replacement parts industries, inc.

## RCH118 HEATER ELEMENT INSTALLATION NOTE

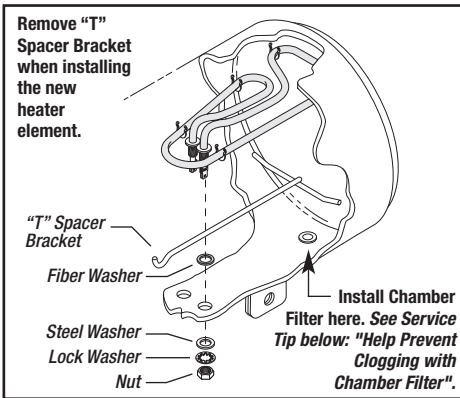
When installing the Heater Element (RPI Part #RCH118) in earlier M7 models, you can discard the "T" Spacer Bracket since it is not needed. This newer style heater element includes spacers attached to the element. See the figure to the right.

*Please note that with some models, it is common that the spacers will not come in direct contact with the chamber.*

With the "T" Spacer Bracket removed, and the new shape of the Heater Element (RPI Part #RCH118), you now have access to the back of the unit. This will allow you to easily install Fill/Vent Mesh Chamber Filter (RPI Part #MIF062) into the Water Fill and Exhaust line to help prevent clogging. See the figure above.
